ADDENDUM NO.1

Bid No. #26-08FAC

CalSHAPE AB841 HVAC Optimizing Program

Colton Joint Unified School District

Calshape Addendum #1
Bid No. #26-08FAC
Attachment A

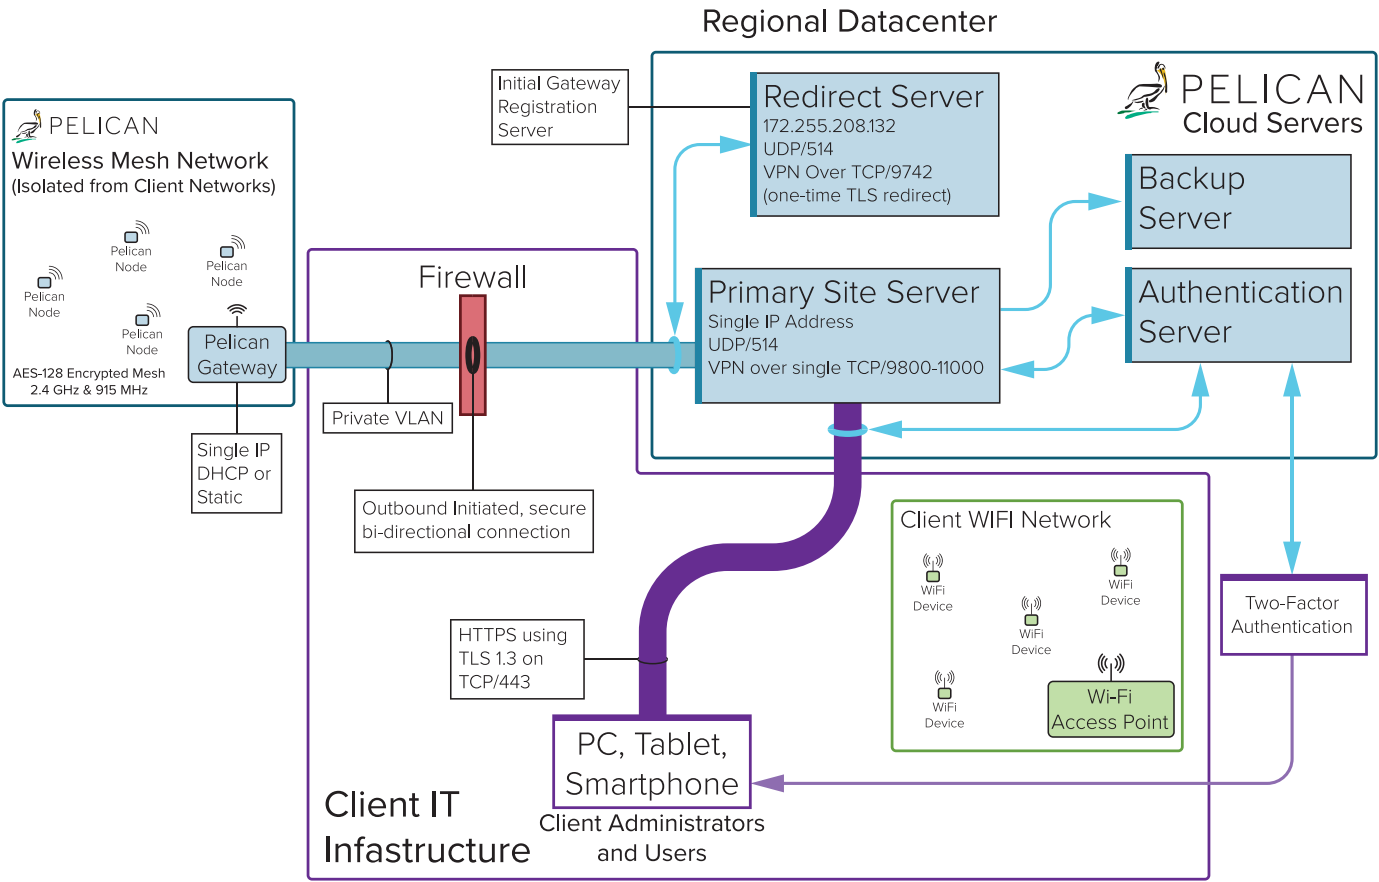
The Pelican GW400 Gateway will be replaced with the new GW900 which features Power Over Ethernet (POE). Refer to Addendum #1, Attachment A
